REF	QTY	PART or DRWG No.	DESCRIPTION	MATERIAL
PARTS and MATERIAL LIST				
LIGO CALIFORNIA INSTITUTE OF TECHNOLOGY MASSACHUSETTS INSTITUTE OF TECHNOLOGY				
PICK OFF MIRROR Mount Gusset Plate ITMX/BSC-4				
GAD FILE		SIZE		DWG. NO.
D990046-B		D		D990046-B
SCALE			SHEET	
FULL			1 of 1

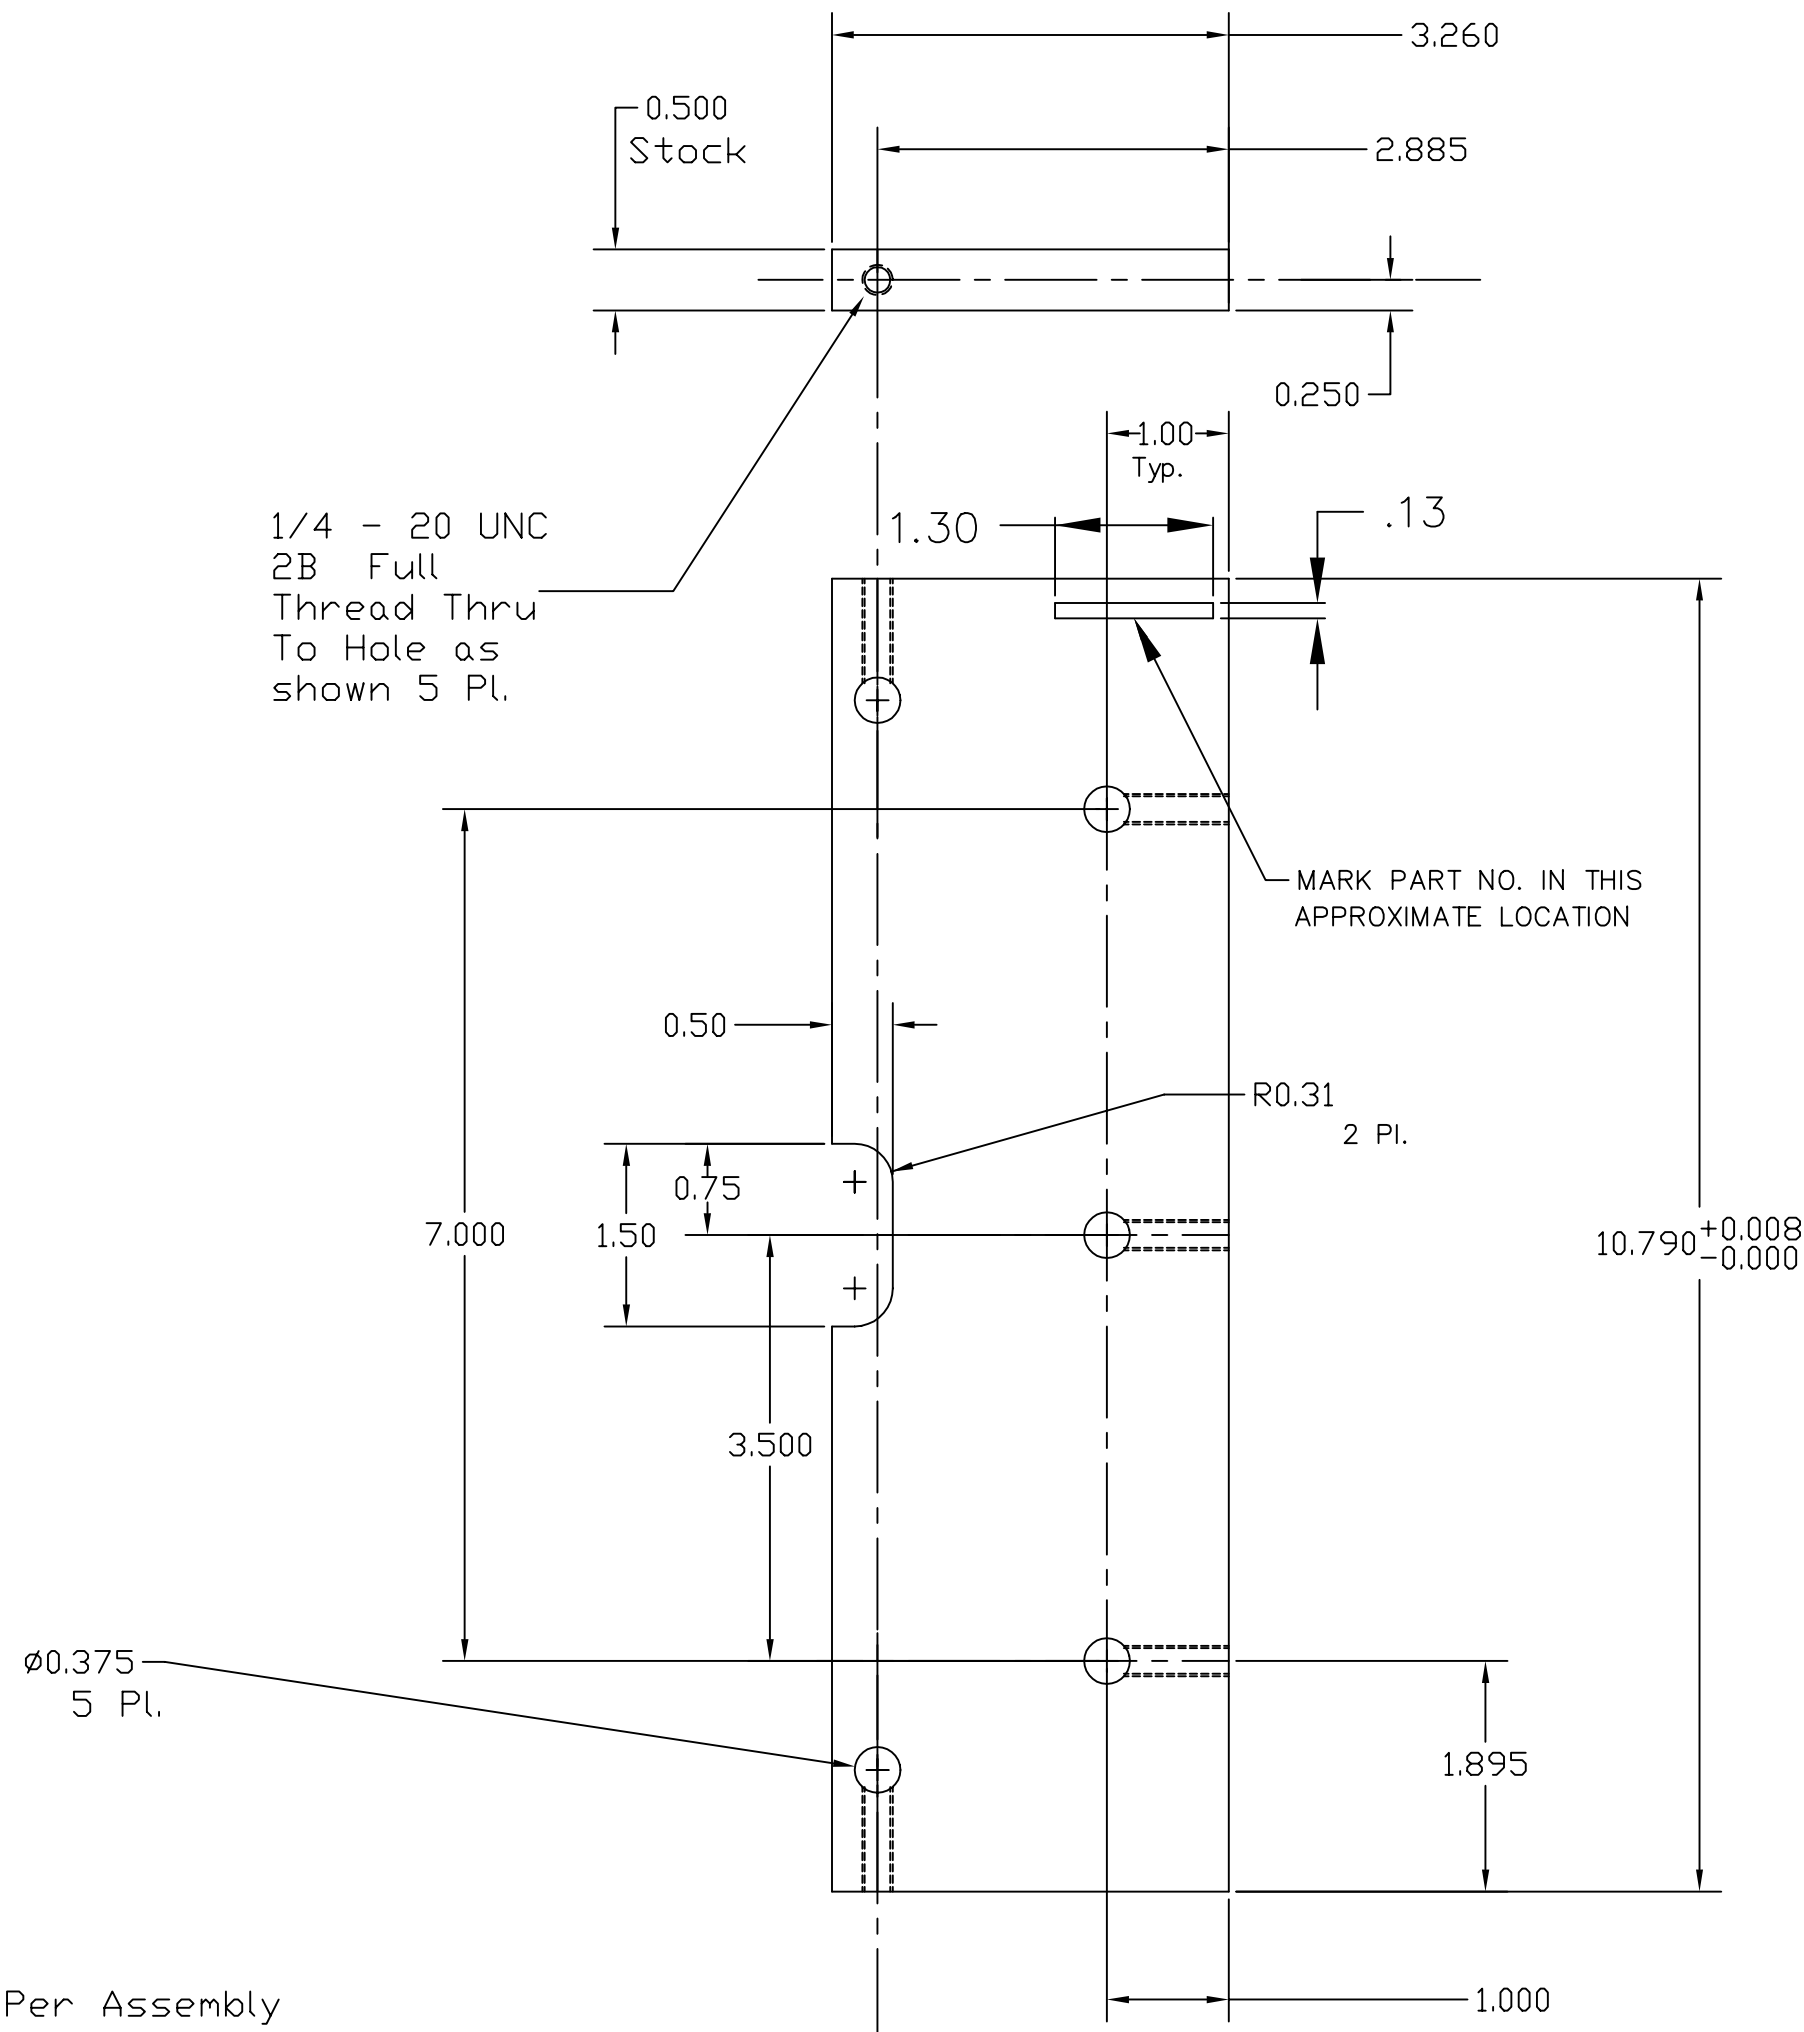
~~Liquids containing hydrocarbons or other contaminants, other than the machining fluids specified herein, shall not be allowed to come into contact with suspension material at any time. All machining fluids shall be water soluble and free of sulfur, chlorine and silicone; such as Cincinnati Milacron's Cintech 410 (stainless steel).~~

~~Identification, Serial Number~~
A serial number shall be etched, or scribed on the part see note drawing note.

~~Serial Number Format~~
The Serial number shall be of the format: D99xxxx-x-xx
